Village/Town of Mount Kisco Building Department
104 Main Street
Mount Kisco, New York 10549
Ph. (914) 864-0019-fax (914) 864-1085

M E M O R A N D U M

SUBJECT: 40 Grove Barn, LLC– 40 Grove Street
Site Plan Application

DATE: May 5, 2023

1 NORTH ELEVATION
 A-3 SCALE: 1" = 10'-0"
 (IN FEET) 1 inch = 10 ft.

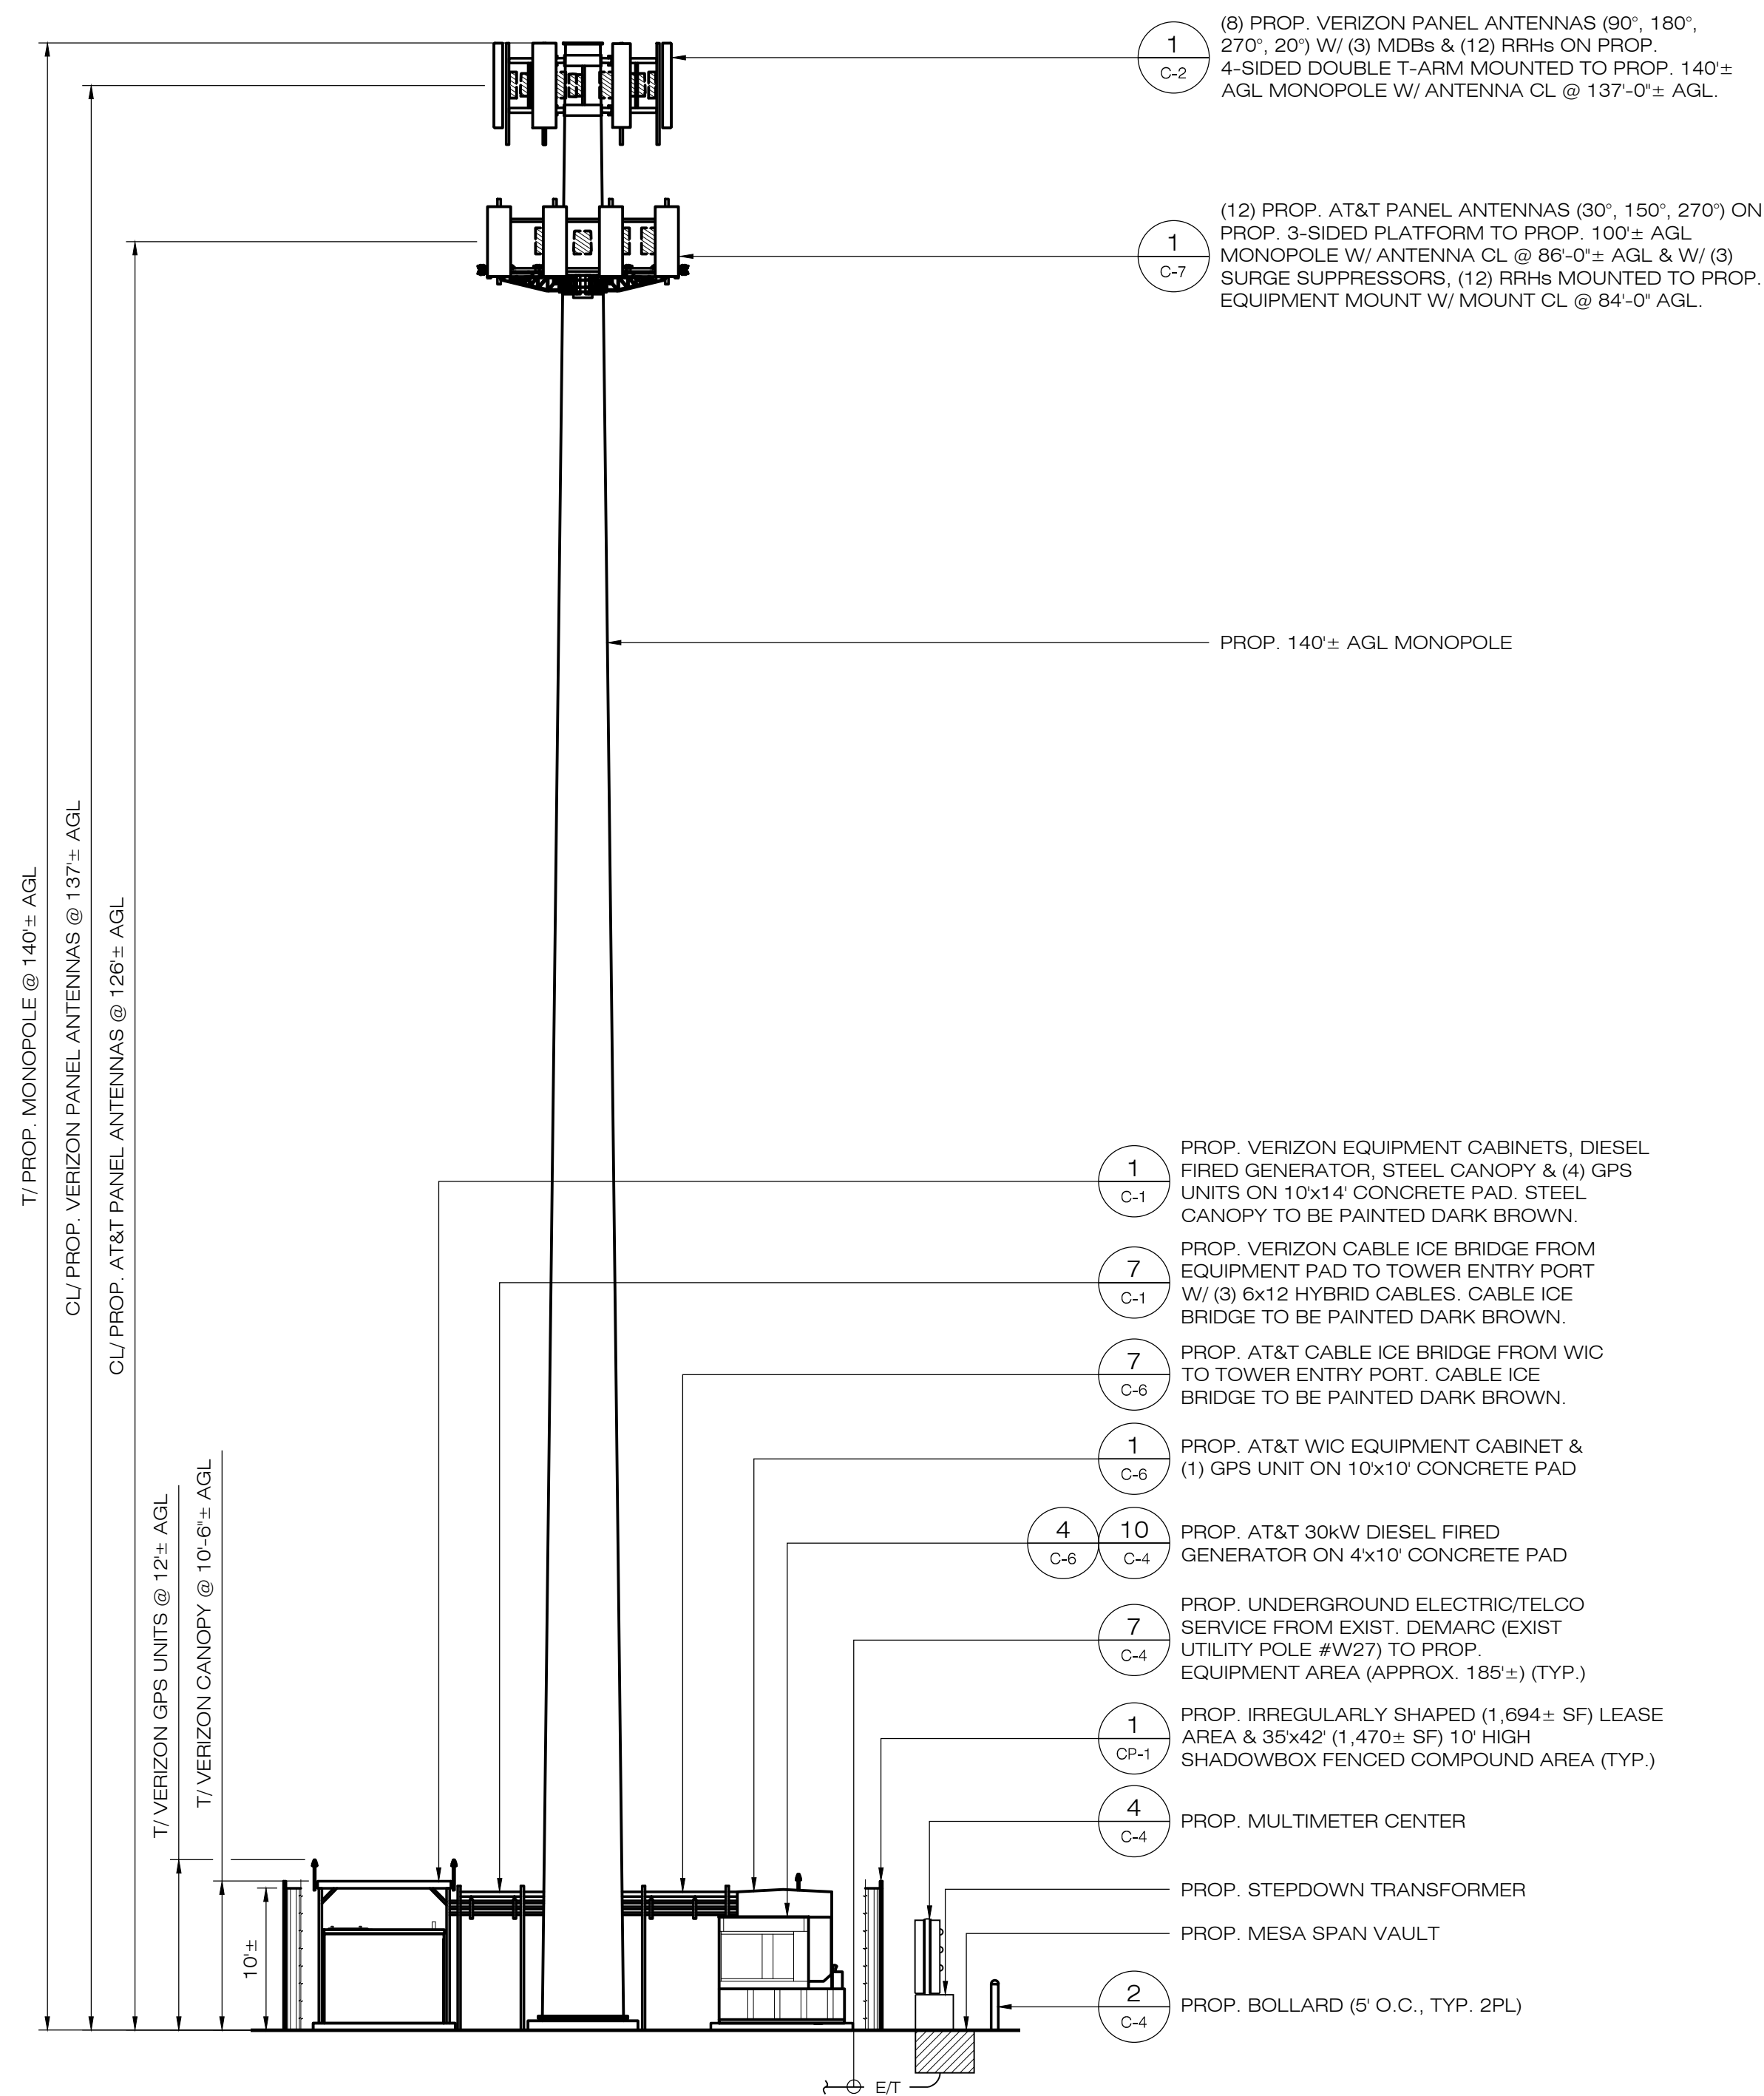
A Tree Preservation Plan has been prepared and is included in the revised Drawing set (Drawings L1 and L2).
- Design criteria of branch density, taper of branches, and maximum feasible extension of branching downward toward the base of the monopole should be implemented. The density of branches shall be at a minimum of three branches per foot. The Site Plan Drawings now show branching extending from 5 ft above the top of the monopole (145 ft above grade level [agl]) down to 70 ft agl; it is recommended that the design extend the branching further downward to 55 ft agl.

- Import notes from On-Site Mitigation Concept #2 (Monopole Design) from the mitigation memo (tree branch density and taper; antenna covers; textures / faux bark; colors and finishes). Evaluate downward extension of branching per mitigation memo.
The notes from On-Site Mitigation Concept #2 have been added to Drawings A-1 and A-2.

A note addressing the branch density of (3) branches per foot has been added to the Drawing A-1 & A-2. The Tower elevations have been revised to extend the monopine branches from 70' AGL to 55' AGL (Drawing A-1 & A-2).
- Monopole texture / color. Faux bark (brown, matte finish) shall be applied to the monopole exterior from grade level to the top of the monopole (entire structure).

The Drawings have been revised to specify a faux bark finish to the proposed monopine (see Drawings A-1 and A-2).
- Antenna covers (“socks”) are proposed and shown in the photosimulations. The antenna covers shall conform to the colors of the stealth tree branching. All visible portions of tower-mounted equipment (cabling, RRH units, distribution box and over-voltage protectors) shall be painted brown (matte finish) as possible to match the monopole color/texture.

3 SHADOWBOX SCREEN FENCE
C-4 SCALE: N.T.S.

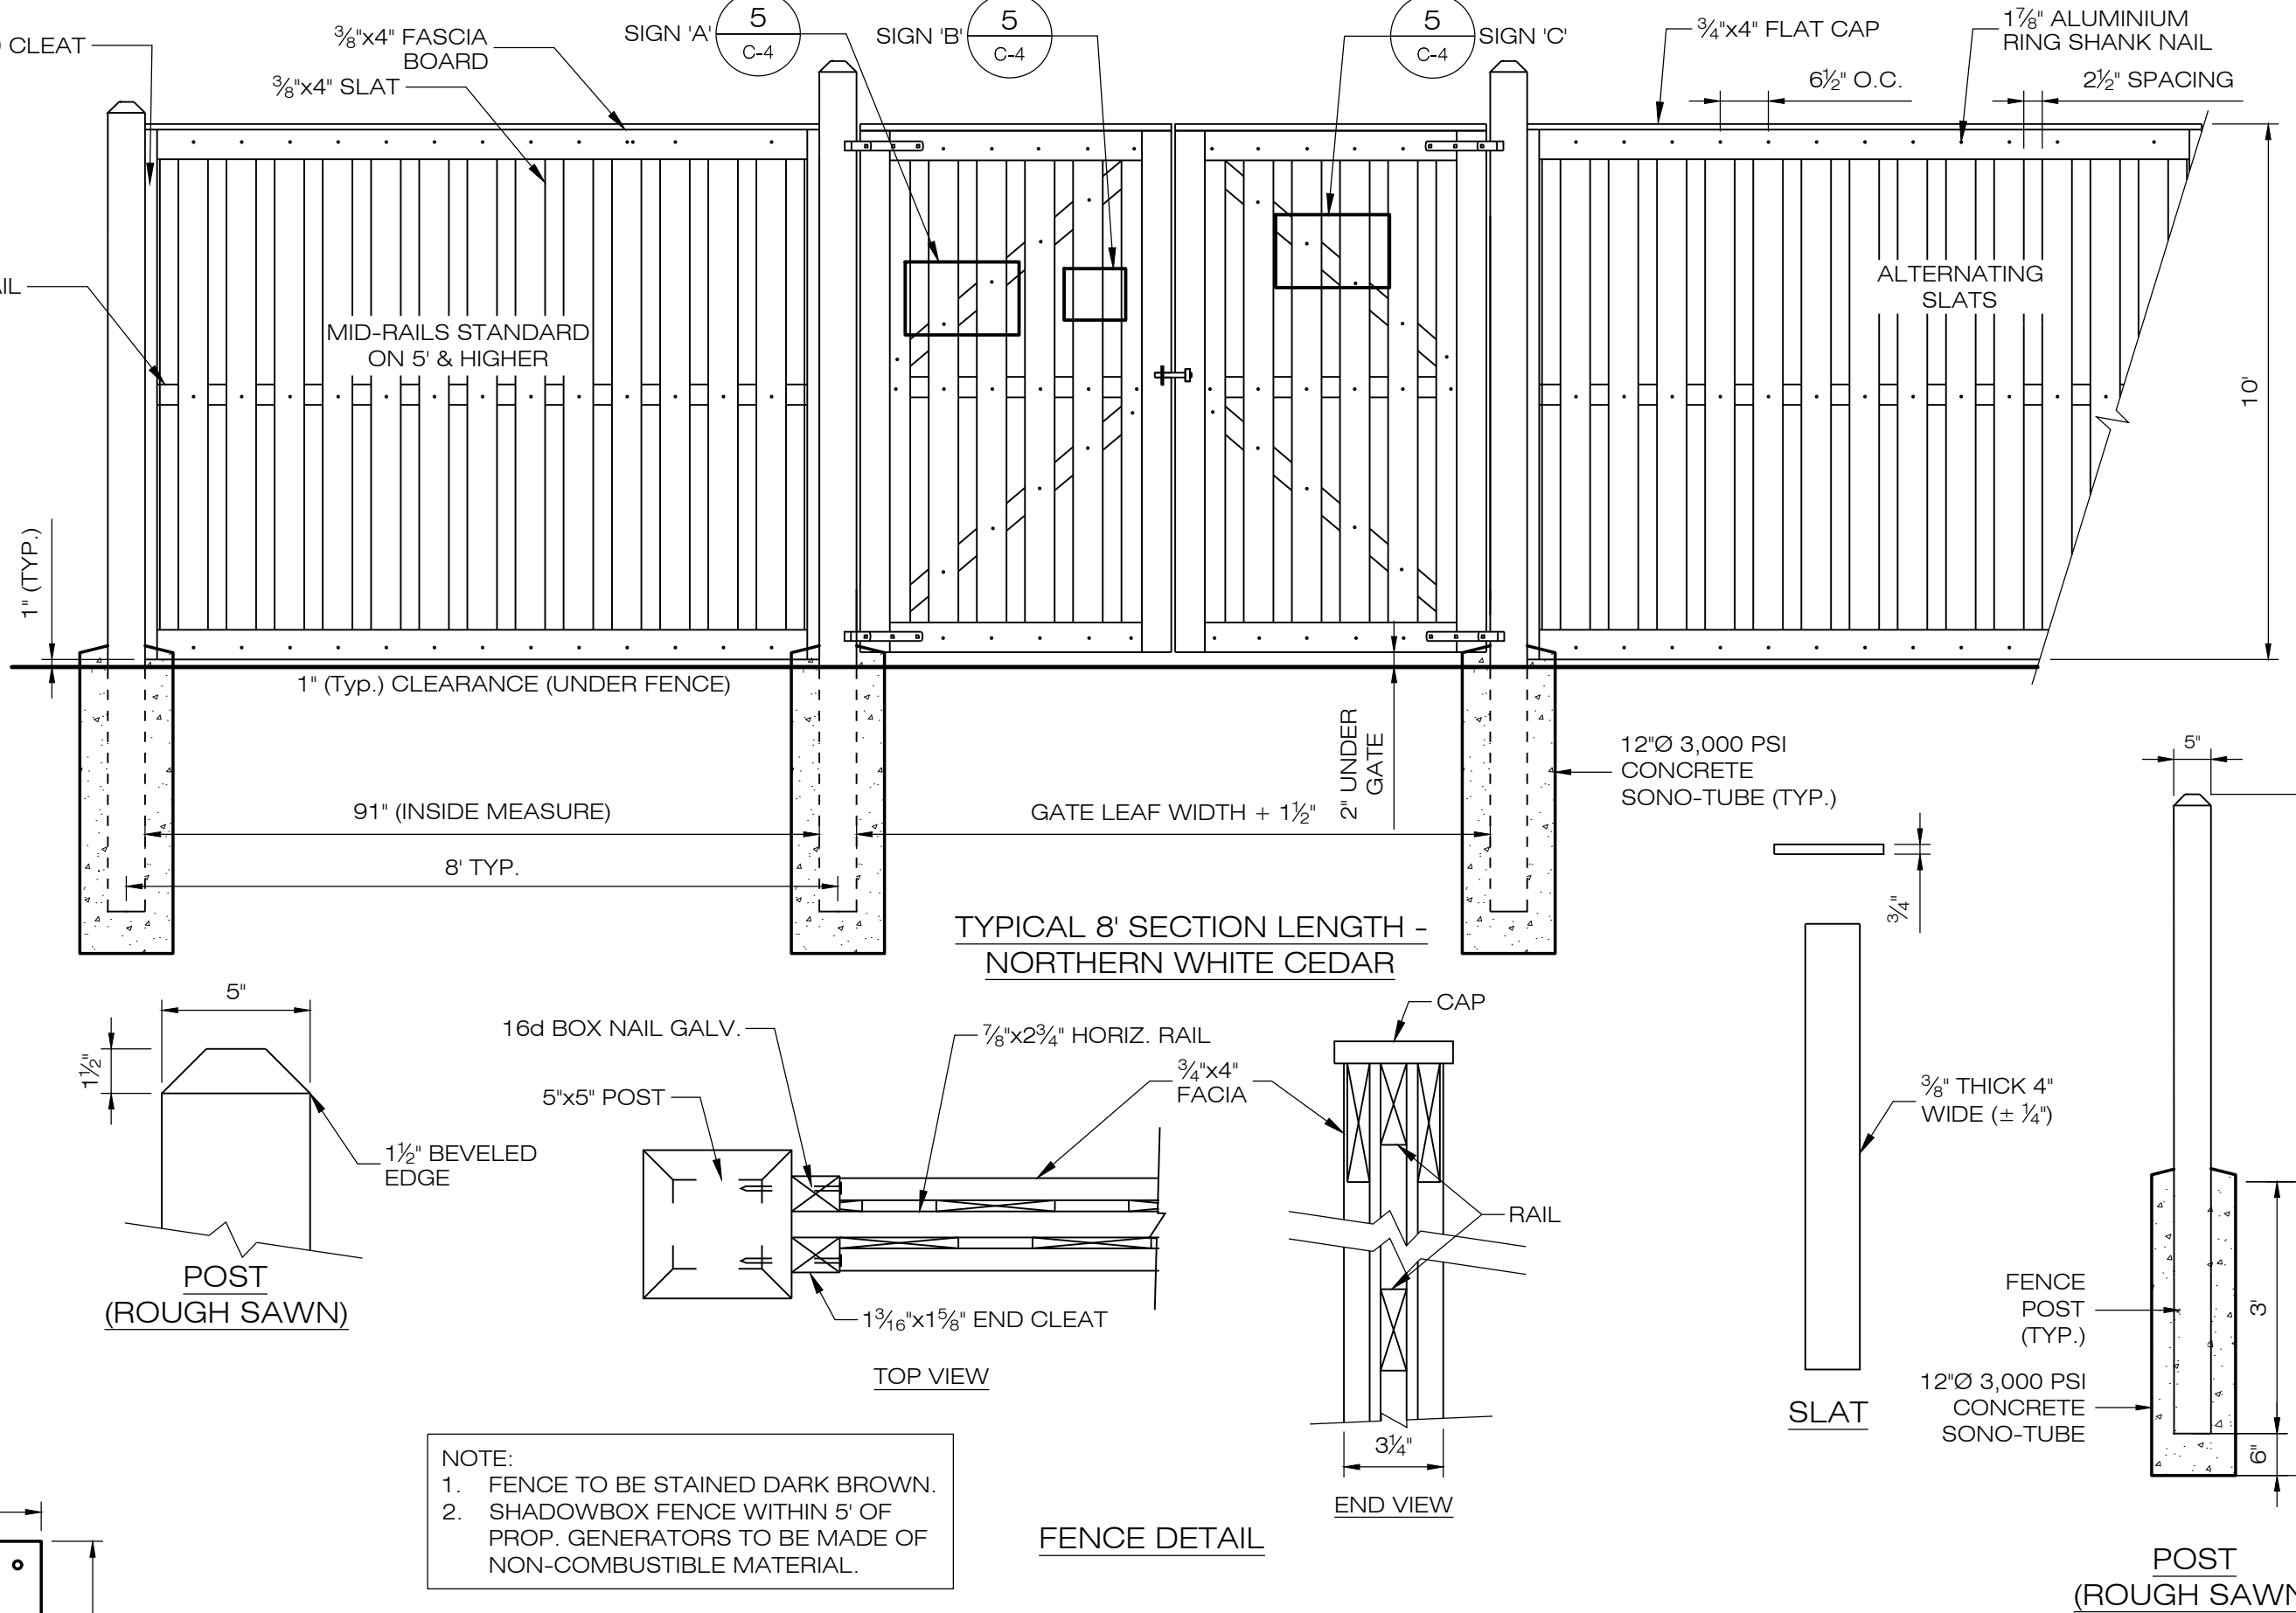
A note regarding the proposed antenna socks has been added to Drawings A-1 and A-2. All other items with the exception of the RRH's will be painted to match the proposed tower.
- It is recommended that the compound fence height be increased to 10 ft on all four sides, and that the fencing be treated as a darker wood (or painted a dark brown to facilitate blending with surrounding tree cover). The equipment cabinet canopies and ice bridge (visible on the photosimulations) should be treated as a dark brown to match the compound fencing color, as an increase in fencing height will not shield the equipment within from all perspectives.

- Import notes form On-Site Mitigation Concept #3 (Compound Design) from the mitigation memo (compound fencing – height and colors).
The proposed fencing has been revised to increase the height to 10’ and notes have been added to the drawings addressing the fence color (see Drawing C-4).

The proposed fence height has been increased to 10' (provided the ZBA issues a variance or an interpretation that such variance is not required) and the fence will be stained dark (see Detail 3 on Drawing C-4). The proposed metal ice bridges and equipment canopies are to be painted dark brown (see Drawings C-1 and C-6).
- To mitigate views from the Marsh Sanctuary property (amphitheater, grave marker, current and anticipated public use spaces, trail connection, Naturalist's cottage [residence]), a lattice fence (treated wood, dark brown; 8 ft in height) is recommended along a portion of the western property line (west of the compound). This lattice fencing may be “staggered” and installed in sections to run between existing trees.

1 STEEP SLOPE PLAN
 SS-1 SCALE: 1" = 30'-0"

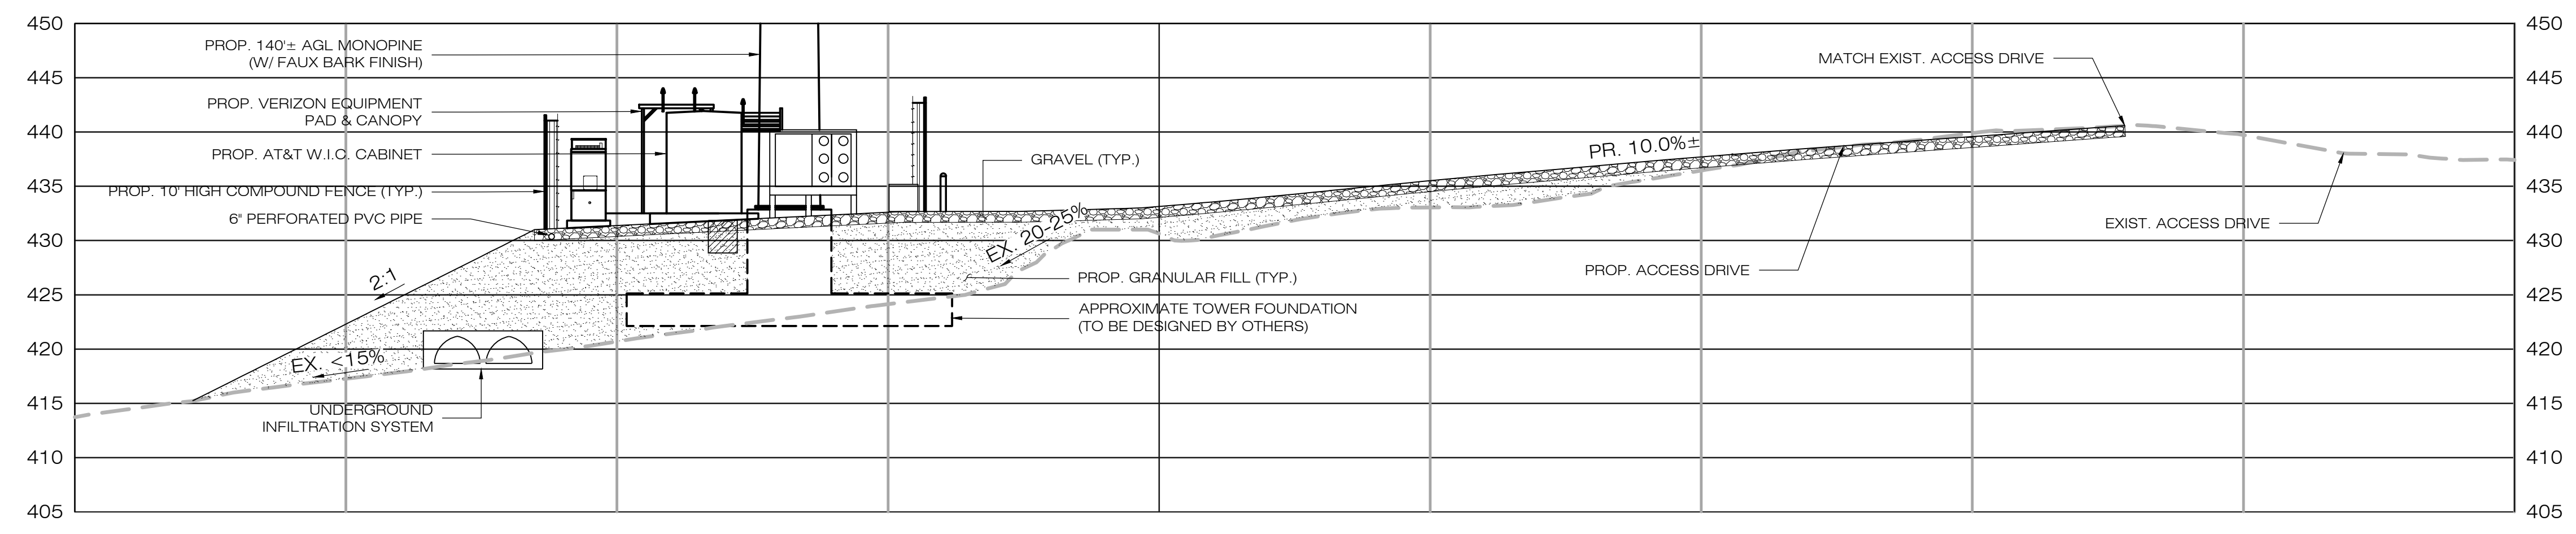
Our previous site plan indicated that a steep slopes permit was required. The applicant clarified that the disturbance area is not located on a steep slope and therefore: a steep slopes permit is not required.

We have added drawing C4 with a steep slope plan showing the proposed work is not in any steep slope area. We also have a landscape plan to show the four replacement trees for the two removed trees and landscaping for the house.
